PLANNING COMMISSION
Regular Meeting
Monday, August 7, 2017
7:00 PM
Christine Nuernberg Hall

Agenda

TO: Planning Commission
FROM: JAC ZADER, ASSISTANT DIRECTOR COMMUNITY DEVELOPMENT
DATE: August 4, 2017
SUBJECT: Raposa Design for Brixmor SPE I LLC. The applicant is seeking conditional use grant amendment approval to allow for an expansion to the outdoor dining patio at 11046 N. Port Washington Road (Chancery).

SITE PLAN

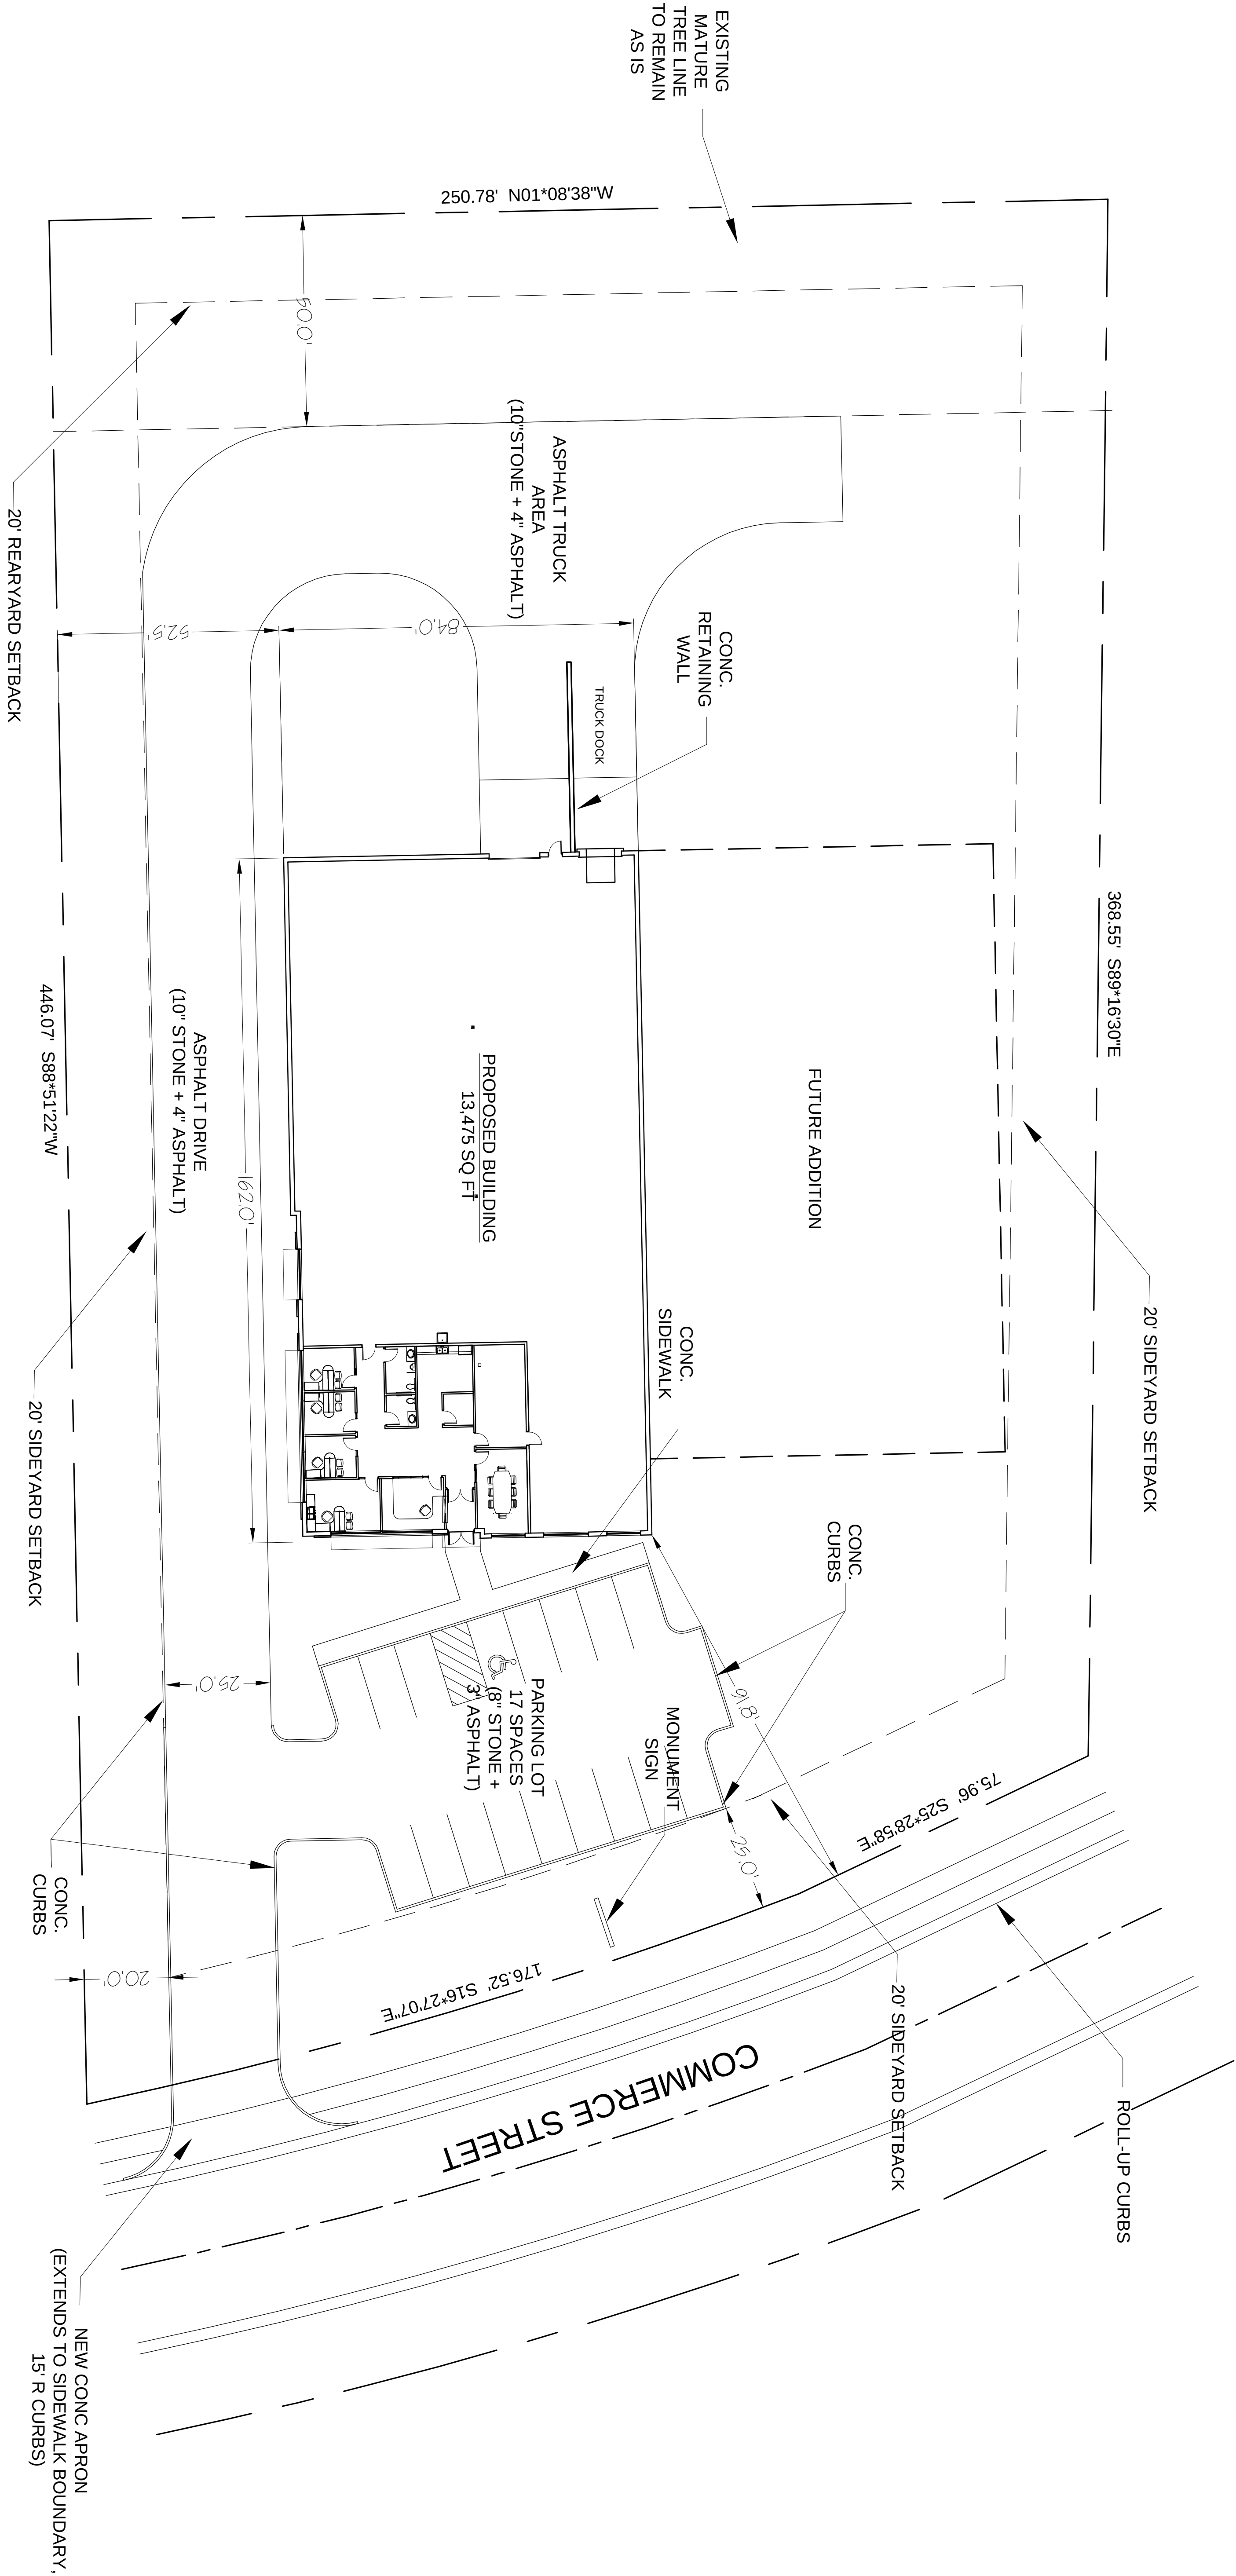
Access to the site is provided by a driveway connection to Commerce Drive. The building is located on the south side of the lot with space to the north for a future addition. Based on the Zoning Code, the proposed uses would generate a parking requirement of 10 spaces. The applicant is proposing 17 parking spaces which will be able to accommodate the demand from the future addition. The plan shows a loading dock on the west end of the building which will be well screened from public view.

7. Planning staff review and approval of final site, landscaping, dumpster, lighting and elevation plans prior to the issuance of permits.
8. Engineering Department review and approval of grading, drainage, stormwater management and sewer plans.

DESCRIPTION: Landscape Plan		
JOB NAME: AV Waterjet Tech Inc.		
LOCATION: 10501 N. Commerce Sreet Mequon, WI		
DRAWN BY: JJ	CHECKED BY: KW	DATE: 5 July 2017

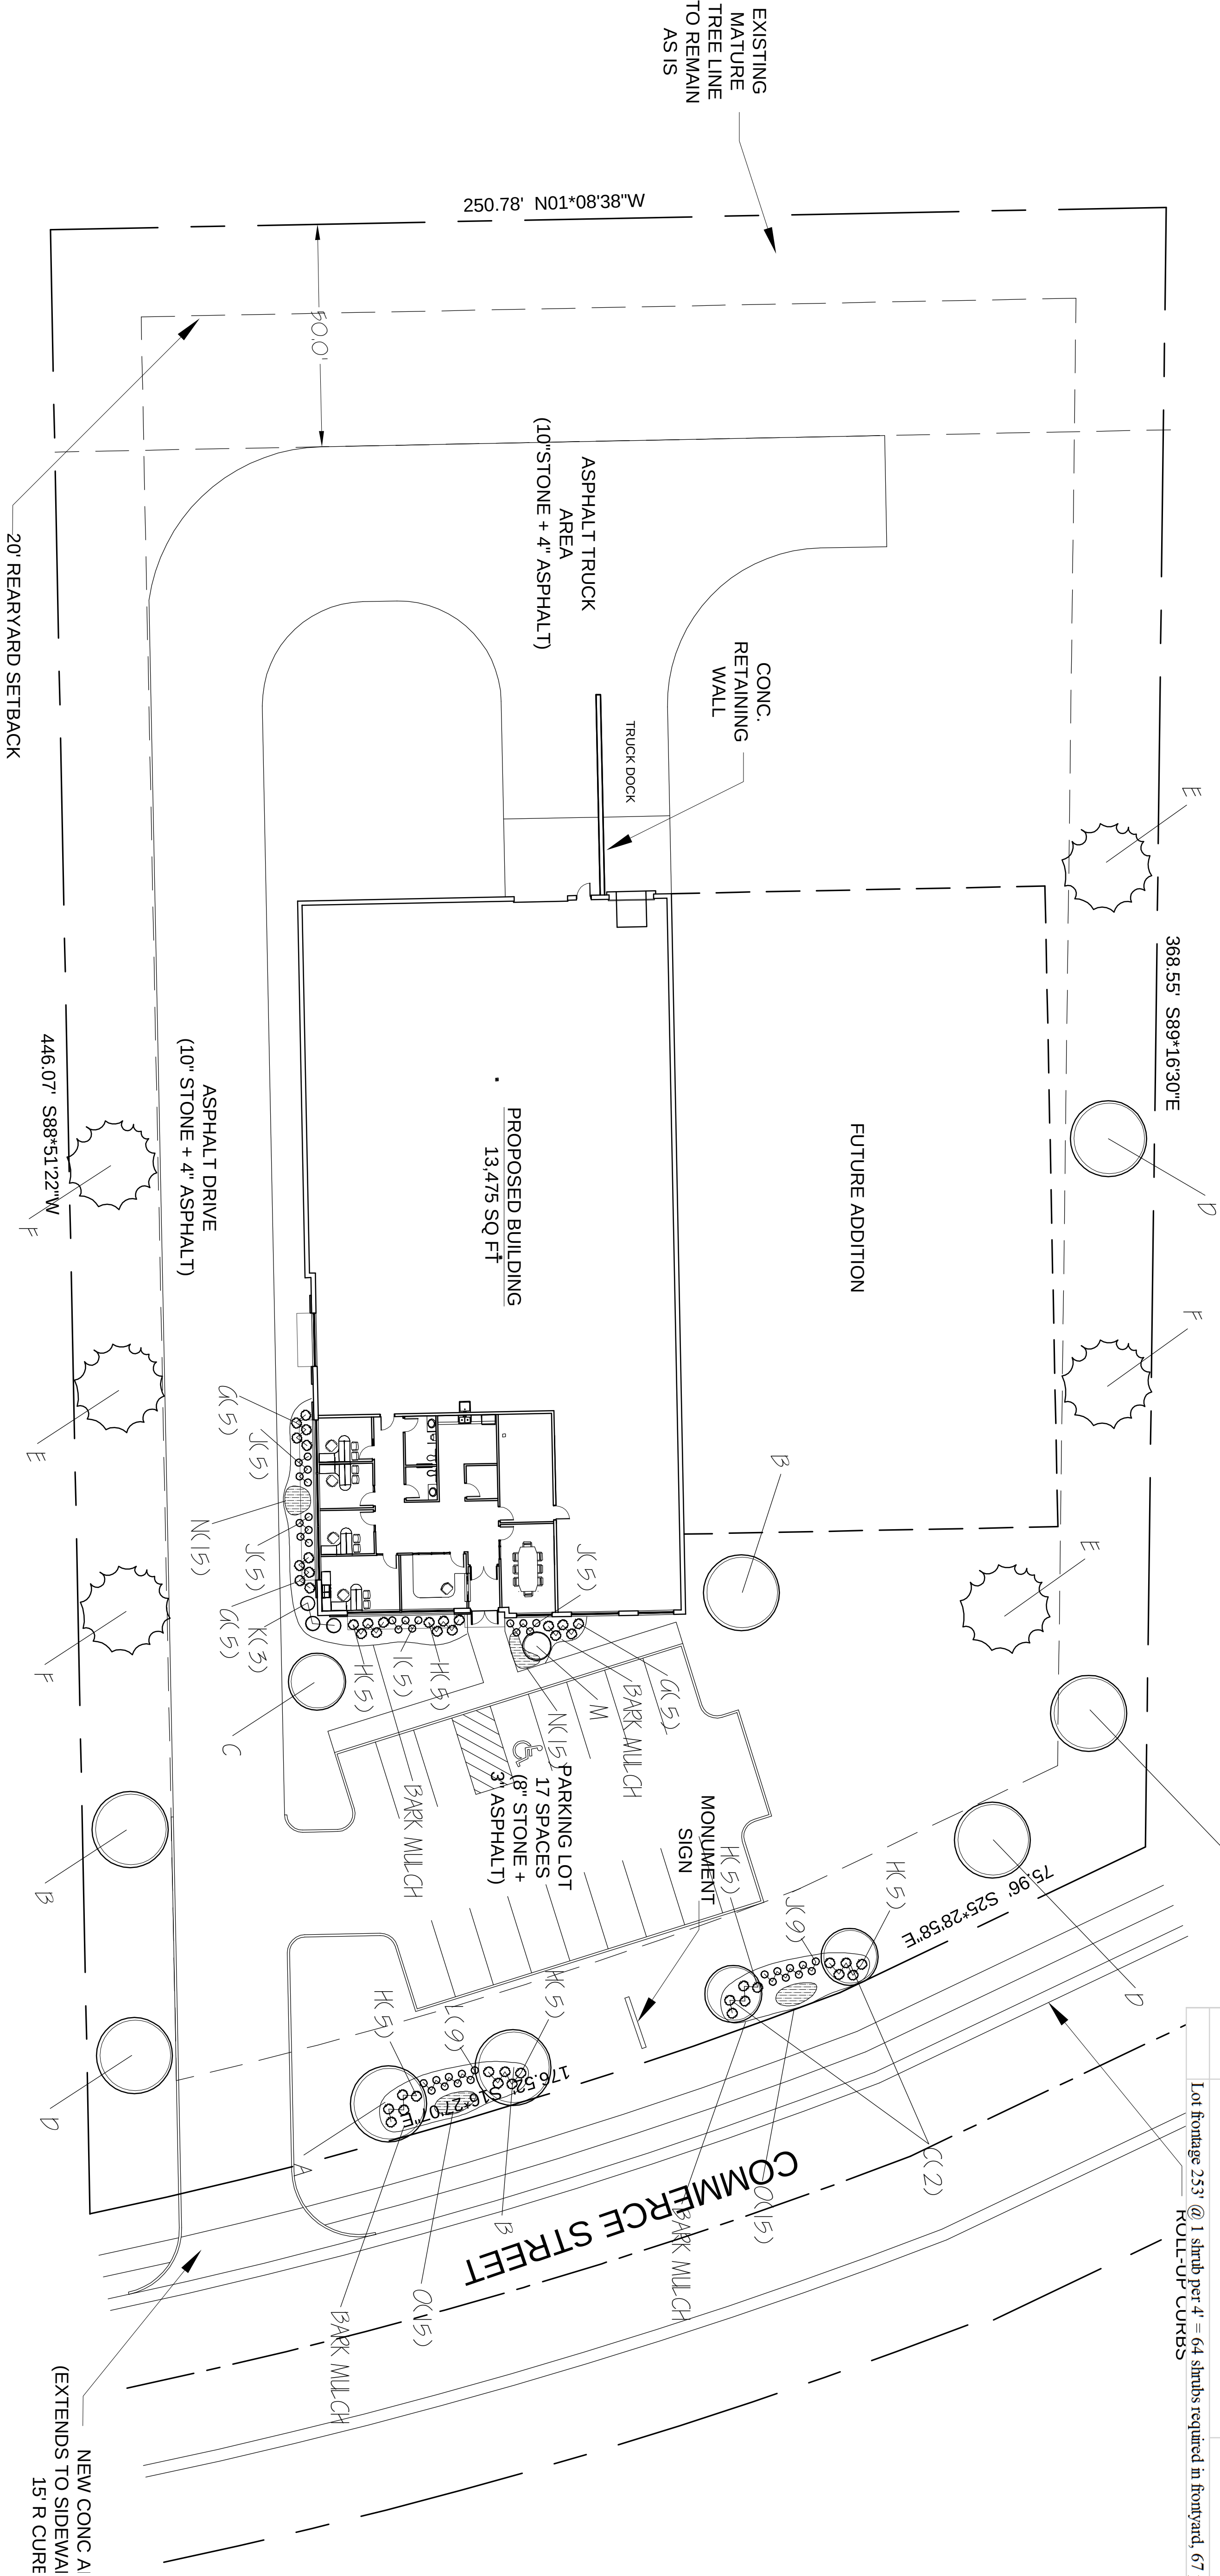
The landscaping plan has been submitted to the city's landscape architect consultant, Terry Higgins for review. Staff did not receive review comments back in time to incorporate into the report. As a condition of approval, staff will require the landscaping plan to be updated to address comments made by the city's landscape architect.

4. Light fixture height maximum of sixteen feet
5. The landscaping plan shall be updated to address comments made by the city's landscape architect
6. A landscaping escrow equal to 125% of the improvement costs for installation of landscaping by a licensed contractor and an escrow equal to 25% of the landscape contract cost to insure that landscaping that dies within three (3) years of installation will be replaced by the applicant.

DESCRIPTION: Exterior Lighting Plan			WS design. a WS Development Company
JOB NAME: AV Waterjet Tech Inc.			
LOCATION: 10501 N. Commerce Sreet Mequon, WI			
SCALE: 1"=20'			
DRAWN BY: JJ		CHECKED BY: KW	DATE: 5 July 2017
JOB NUMBER: 17.101		SHEET: E 1.0	
COPYRIGHT 2017 WS DESIGN		ALL RIGHTS RESERVED

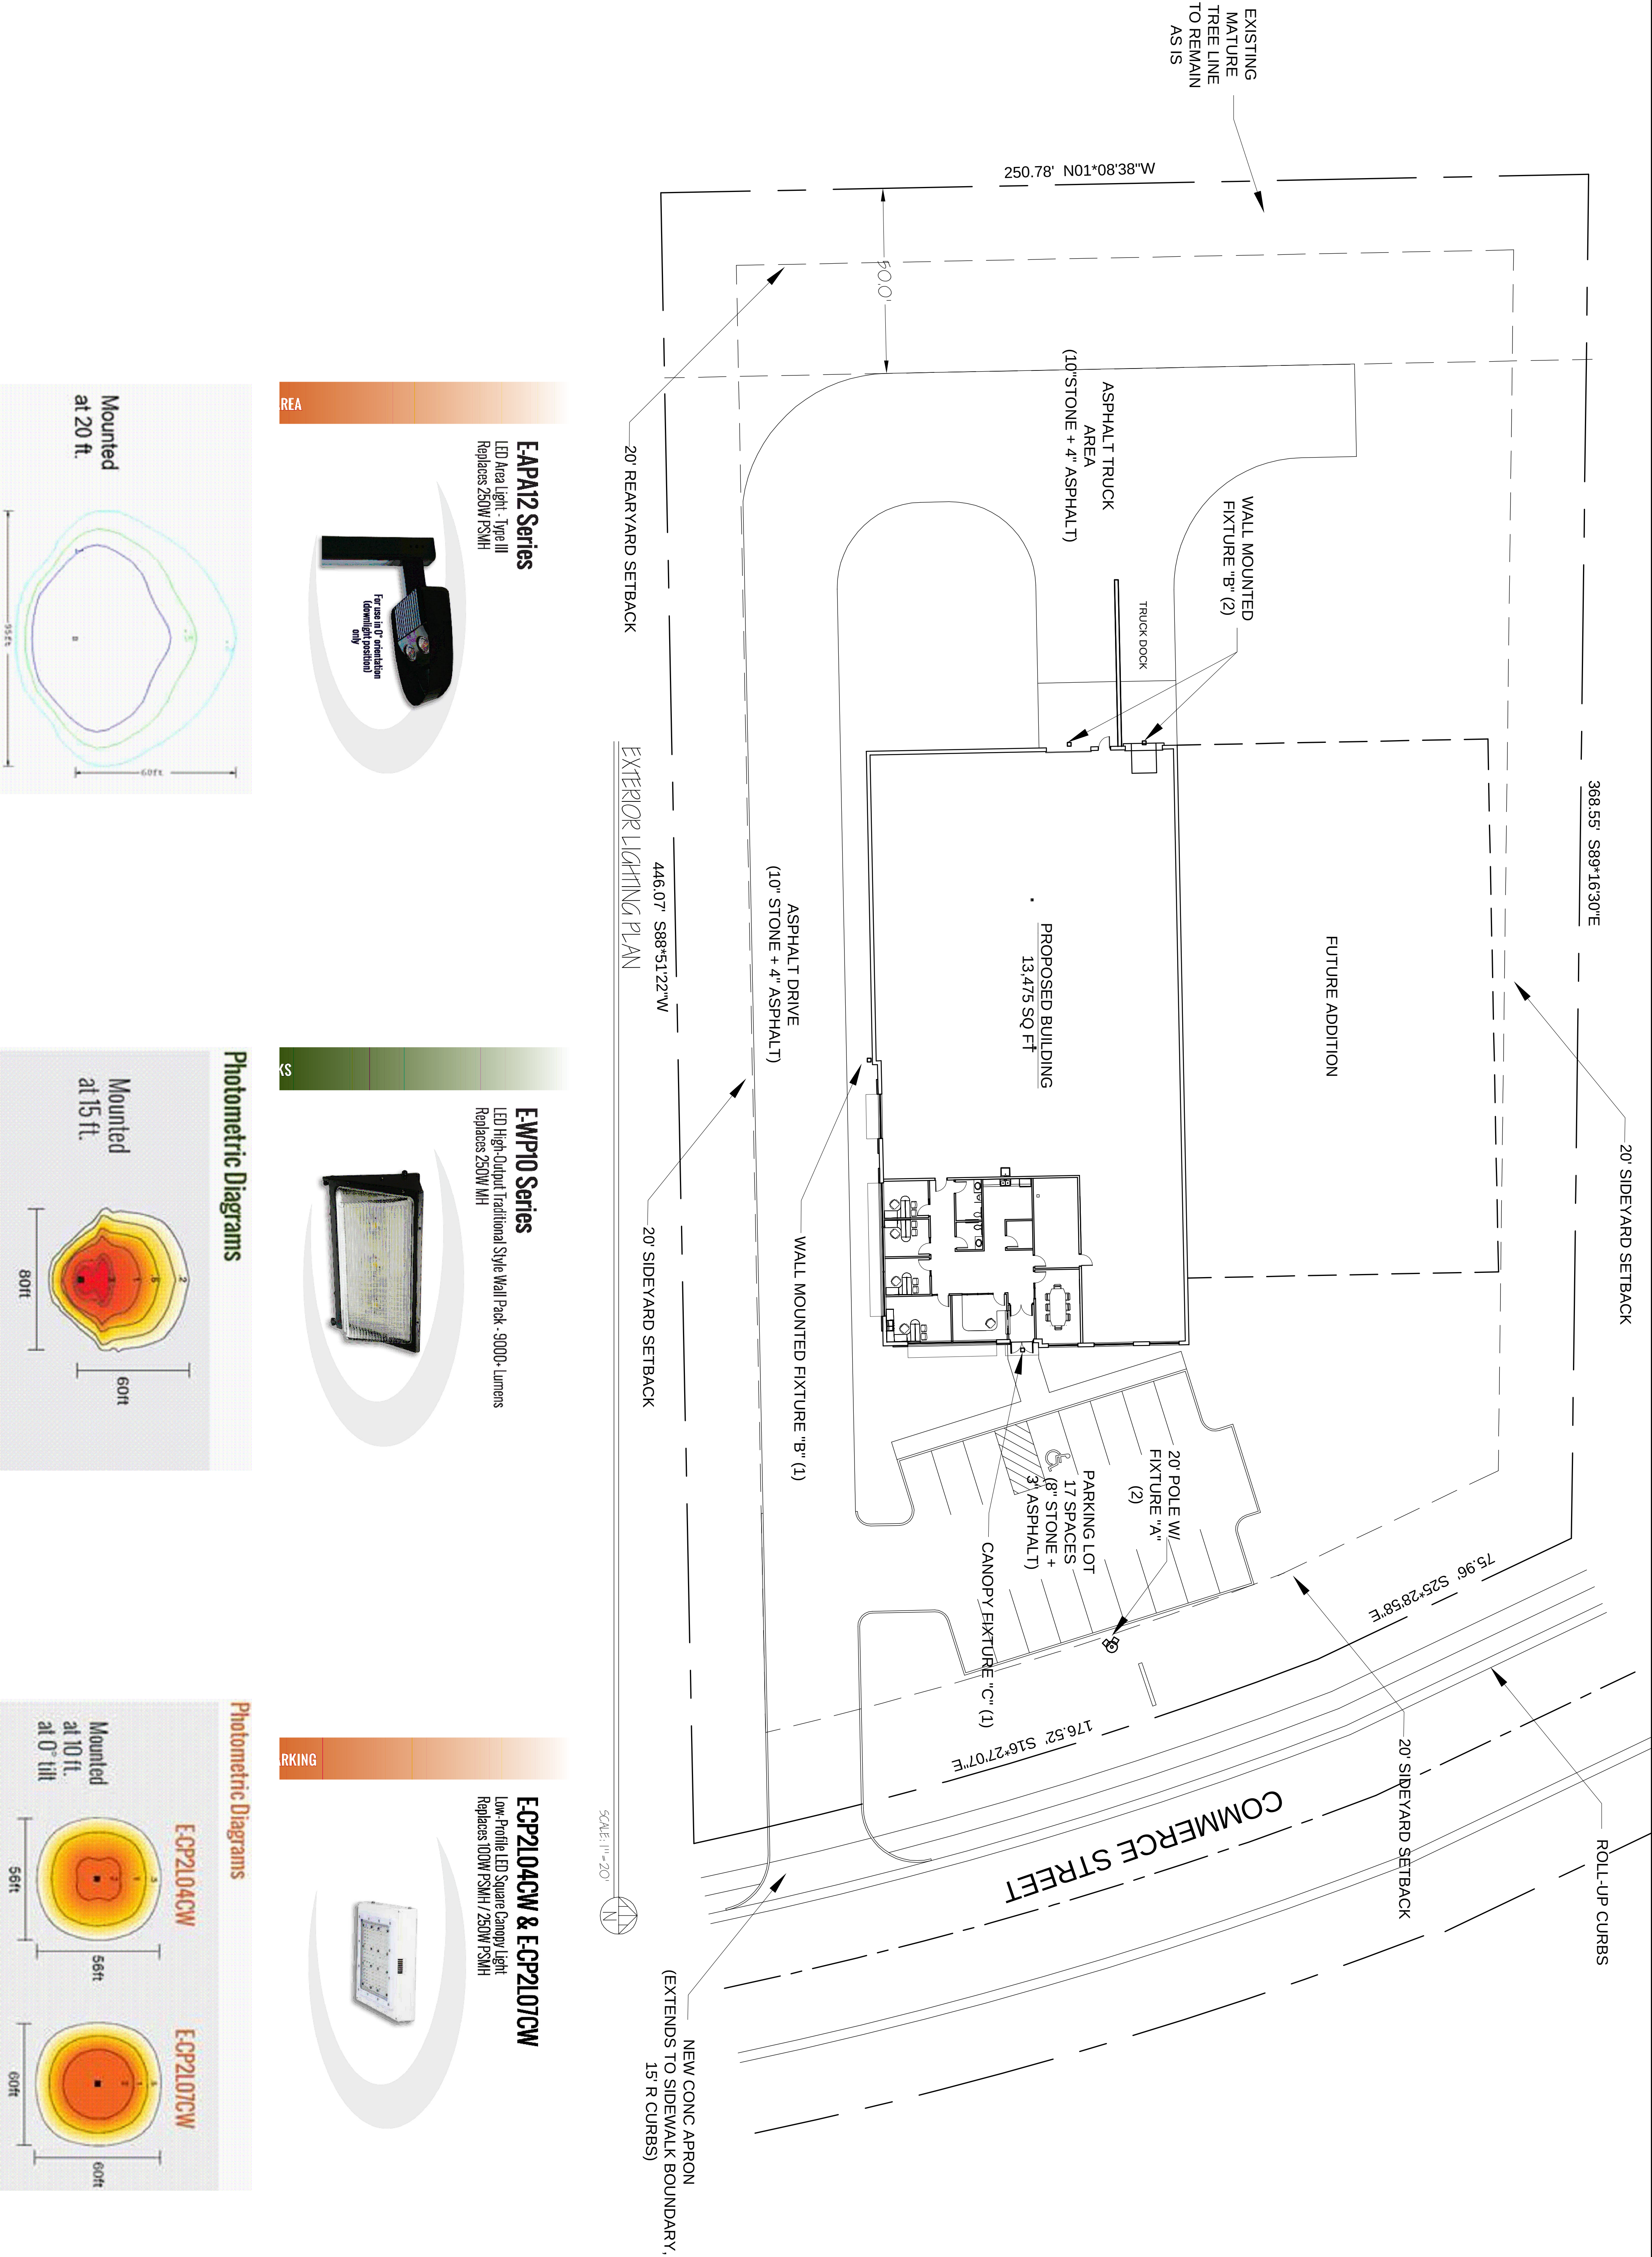
The proposed lighting plan shows one parking lot light, two wall packs and a canopy light. The parking lot light fixture is shown at 20 feet in height. Based on the height of the building, the code requires a maximum height of 16 feet for the parking lot light. The plan does not include a dispersion plan or cut sheets for the fixtures. Staff will add as a condition of approval, the submittal of a dispersion plan and cut sheets as a condition of approval.

3. Submittal of a revised lighting plan that includes a dispersion plan and cut sheets for staff review and approval. All fixtures shall be classified as full cutoff.
